13 May 2011

**Report on the Proposed Residential Subdivision
at Catherine Hill Bay by Coastal Hamlets Pty Ltd**

7.1 Stage 3

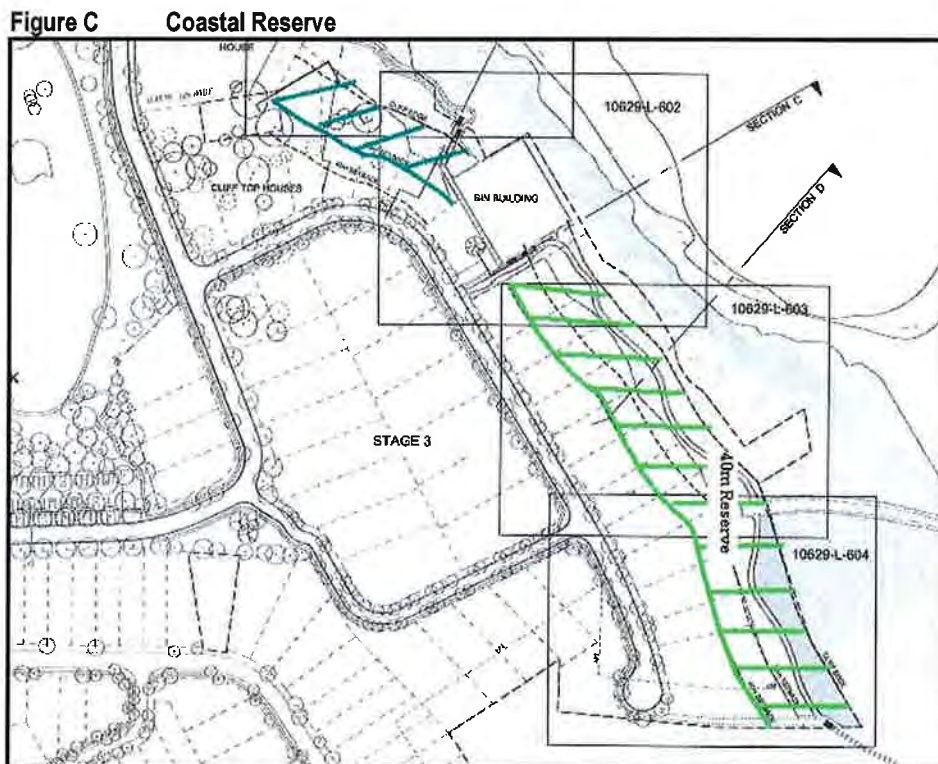
Stage 3 is identified in the Major Projects SEPP as part of the Heritage Conservation Area. It is located on a highly sensitive headland where future development could impact on the heritage significance of the existing Catherine Hill Bay village. The scenic quality of the coast must also be protected. Any development in this area must be sensitively treated to ensure minimal intrusion into the visual catchment of the village and the scenic quality of the coast.

The proposed coastal reserve and walkway is a significant public benefit of the proposal. The IHAP recommended a 25m coastal reserve from the cliff line. In response to public submissions, the Department recommended a 40m coastal reserve as well as a perimeter road to be provided adjacent to the reserve for easy public access.

The Commission supports a 40m coastal set back from the cliff line south of the Bin Building. To the north of the Bin Building, the coastal reserve should be 25m from the cliff line as the coastal walk would be below the cliff line. However, the set back is required for visual impact and safety reasons. (see Figure C)

The Commission questioned the need for the perimeter road, particularly when the coastal reserve is increased from 25m to 40m. If the extra 15m reserve is well vegetated, it could provide a very substantial boundary between public and private properties as well as protecting the scenic quality of the coast. With a well designed public area in the Bin

The coastal reserve should be constructed as part of Stage 2 to allow plantings to be well established to ensure housing development when occurs will be within a well landscaped area to minimise any potential intrusion into the visual catchment of the heritage village and the scenic coastal area.

- (j) Stage 3 of the development is to be redesigned to provide for a coastal reserve including the coastal walk. The reserve must be 40m from the cliff line south of the Bin Building and 25m from the cliff line north of the Bin Building. The cliff line is defined as the line that represents the point where the land at the cliff edge has a slope of 20%. Private property must not encroach onto the reserve.
